Ladder from Taiwan

Test & Inspection

Rachid Nouicer, Milan Stojanovic

Number of entries

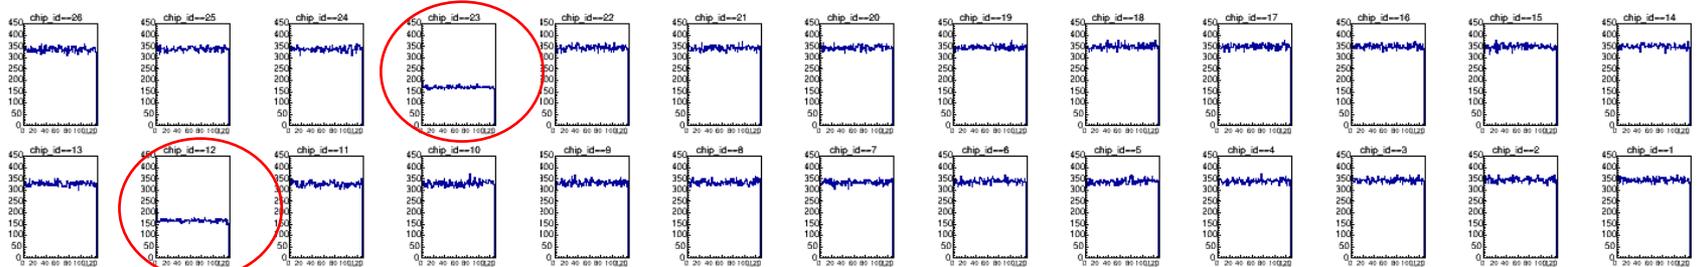
We observed two chips with half entries, U23 & U12

Module 264 with bias

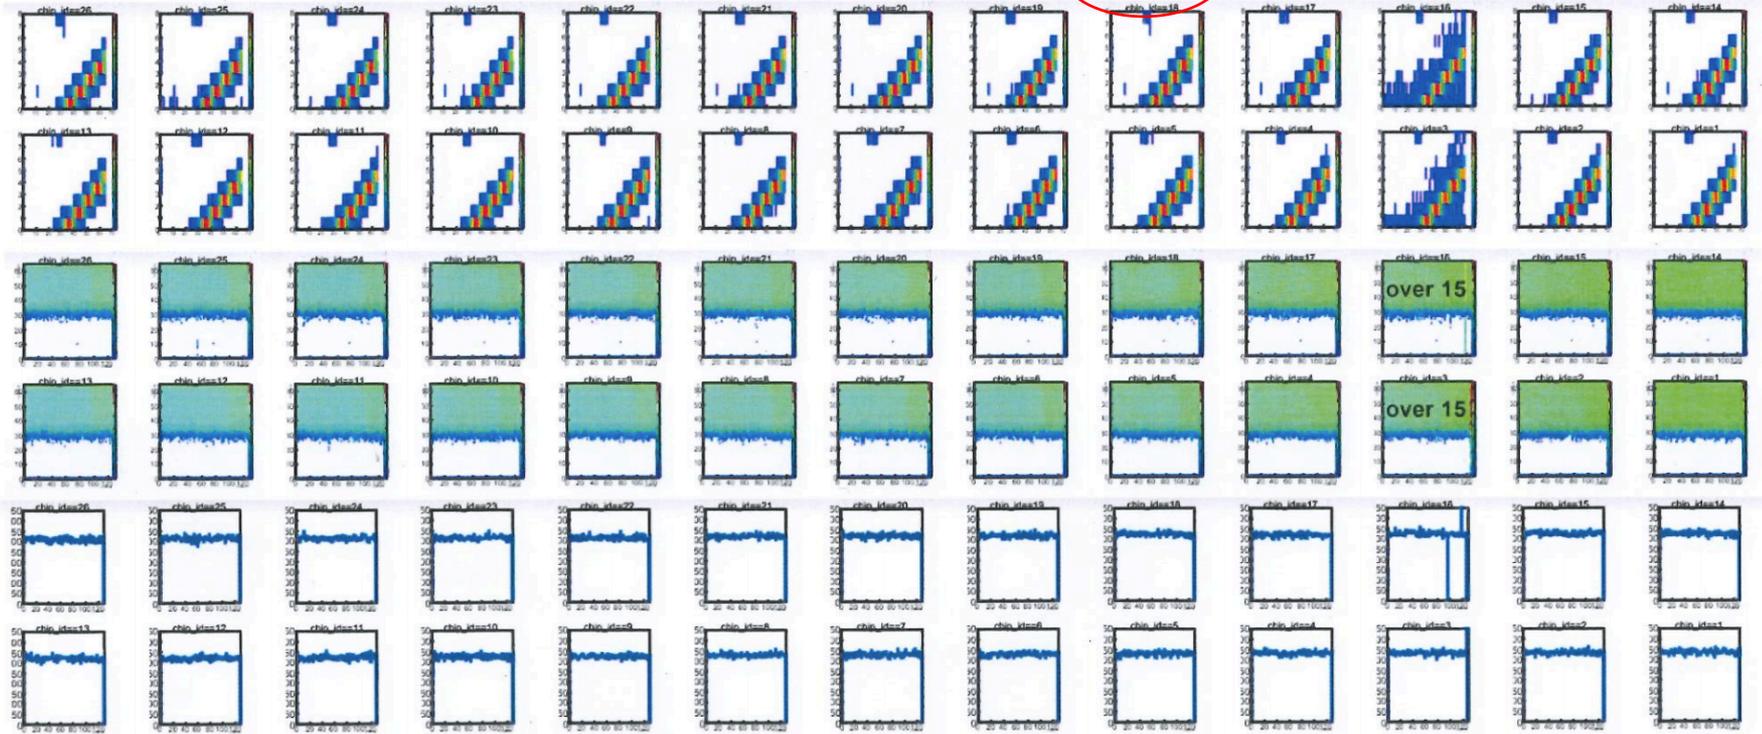
Sensor B has a high current

Visual Inspection

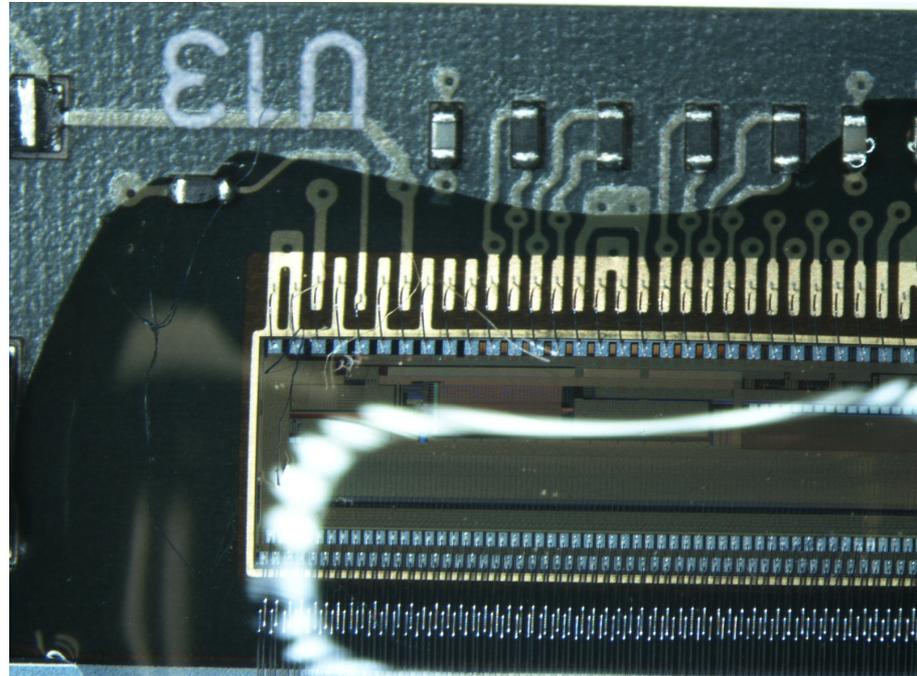
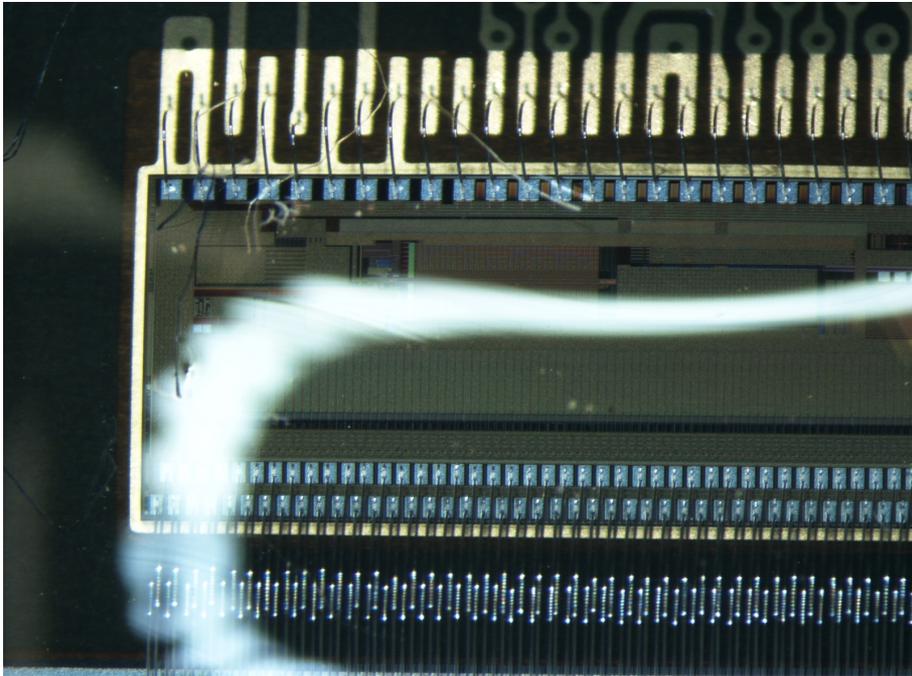
- Lot of fibers observed on the chips

Visual Inspection

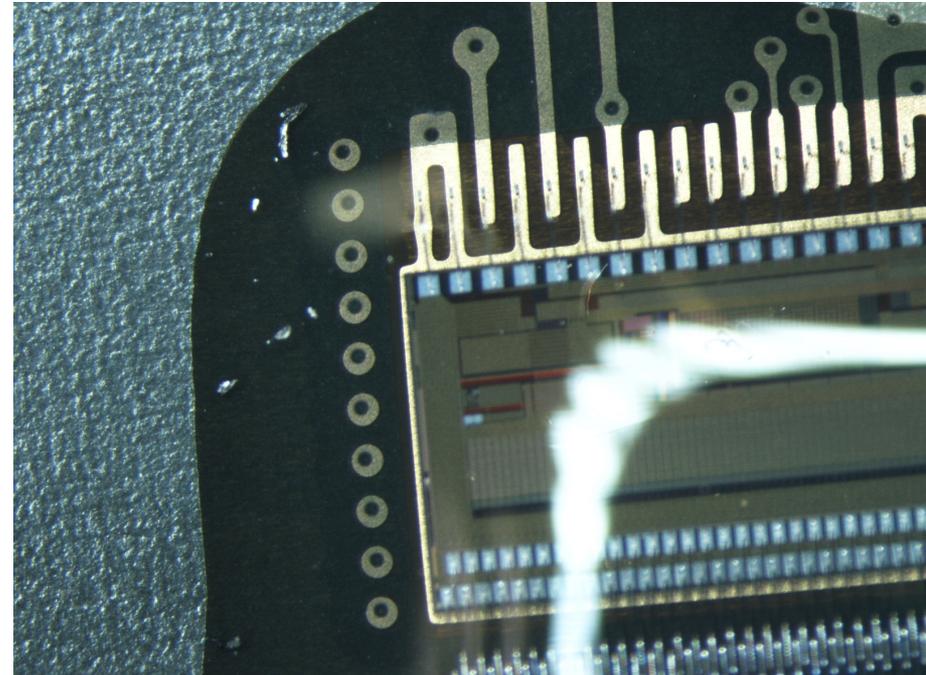
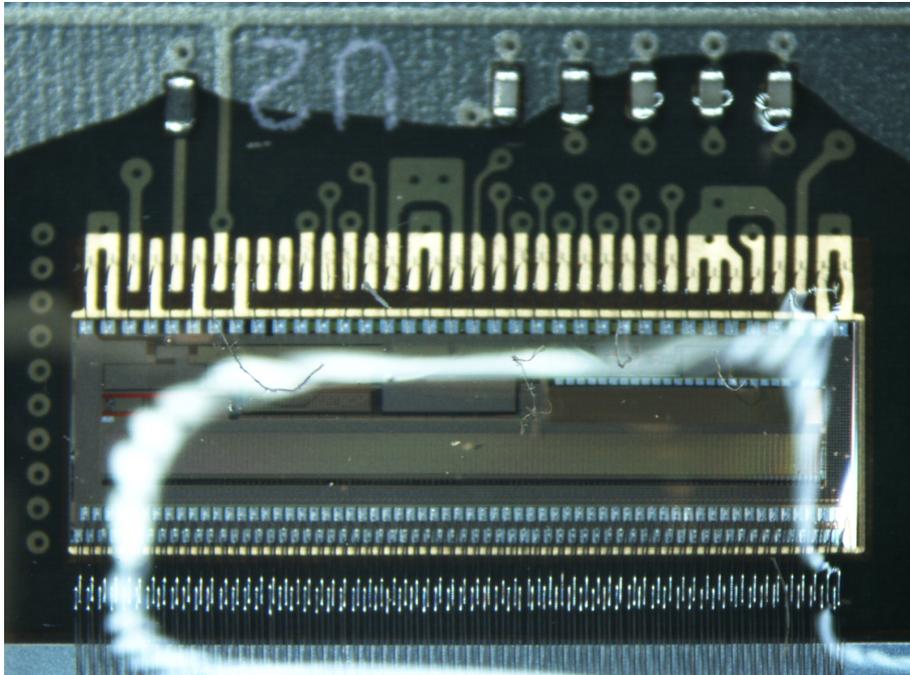
- Lot of fibers observed on the chips

Visual Inspection

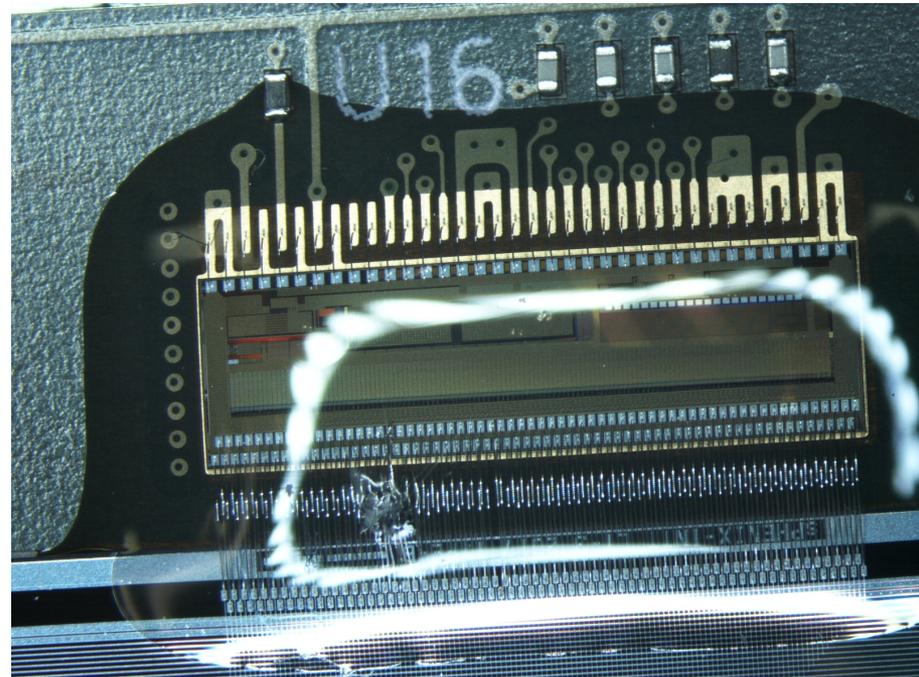
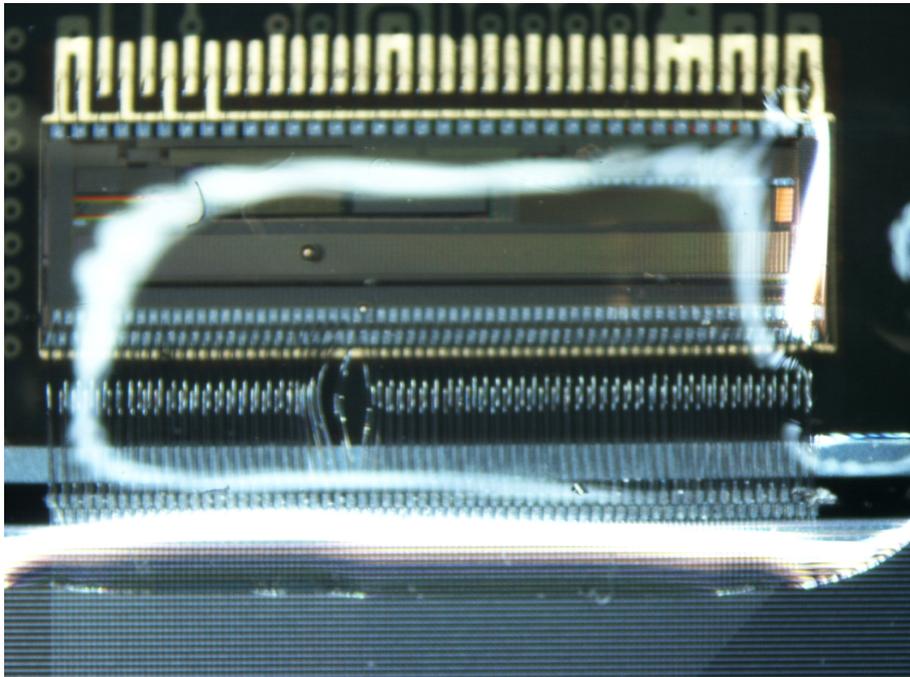
- Wire bonding can be improved

Visual Inspection

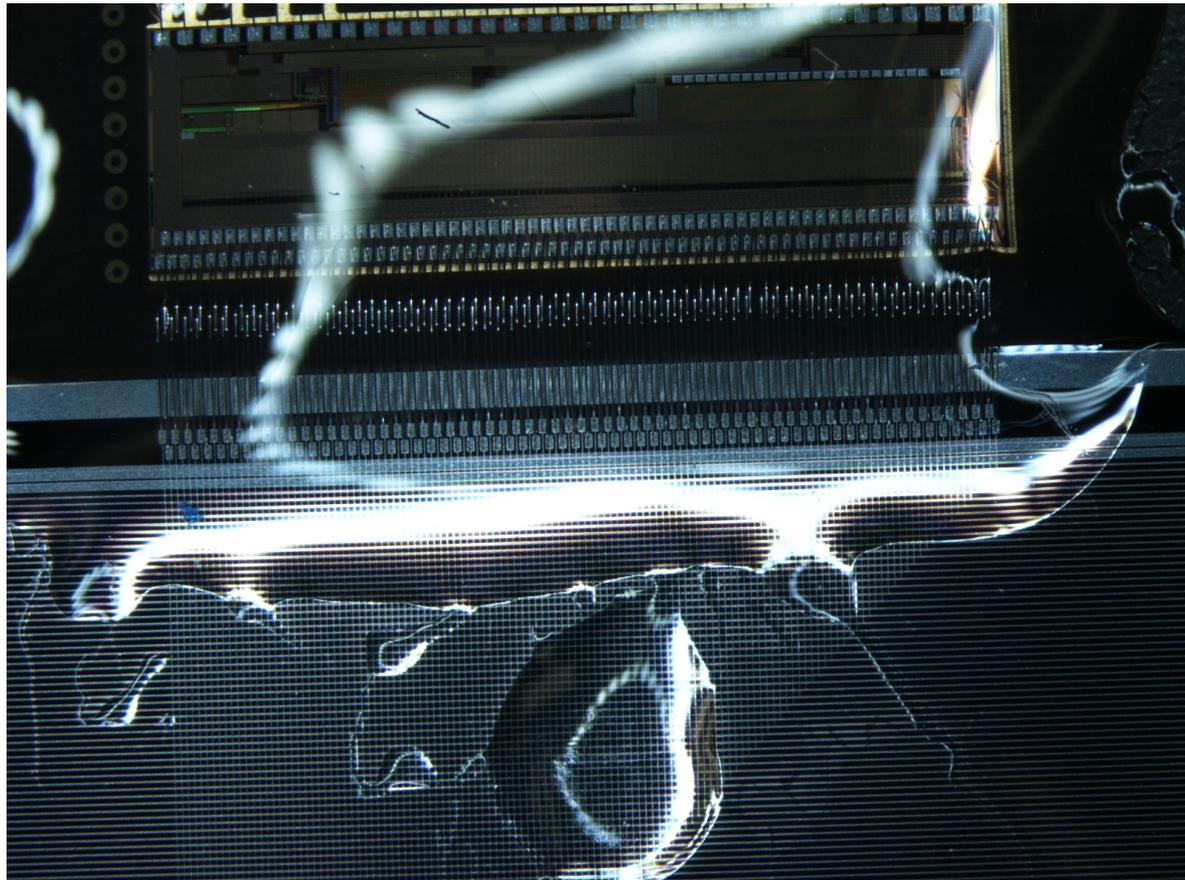
- Encapsulation on the sensor → needs improvement,
- concern: it seems that height of encapsulation is bigger than 1.2 mm

Visual Inspection

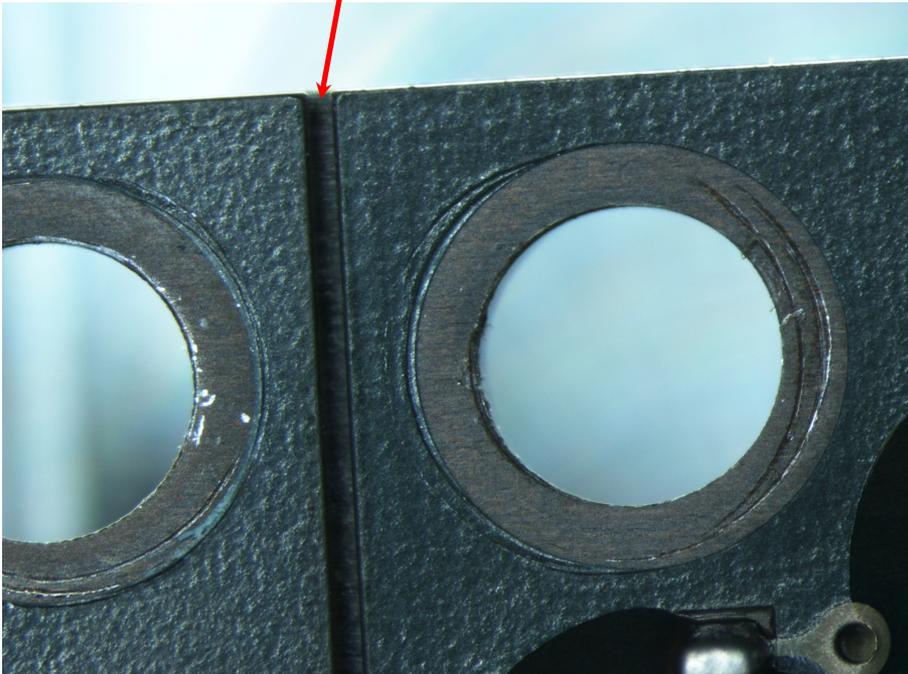
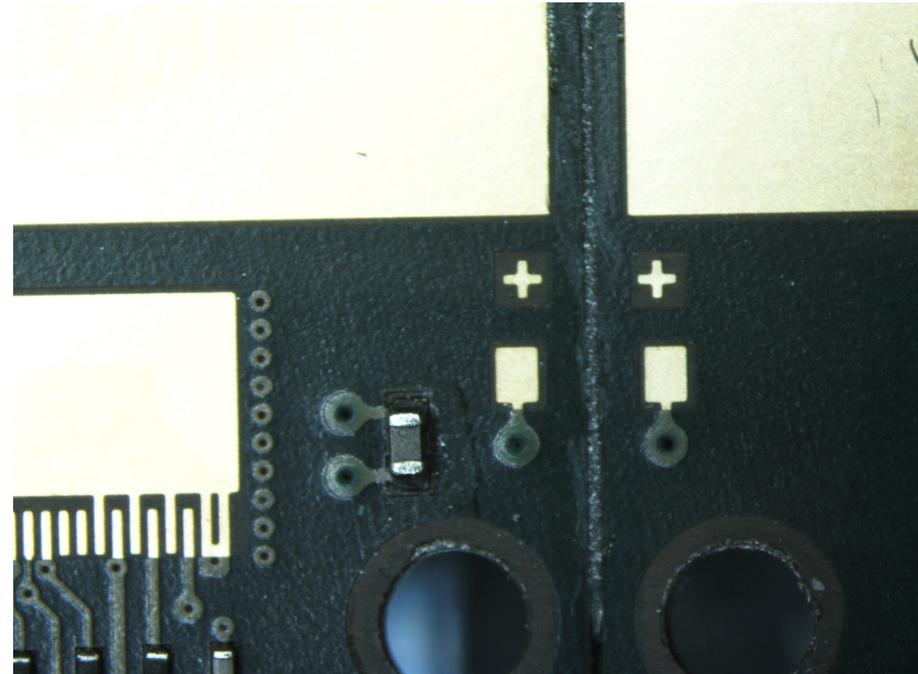
➤ Gluing issue: Big concern!

- We didn't observe the glue between the two adjacent HDIs nor between the HDIs and the stove
 - This implies the ladder will run hotter than BNL ladder
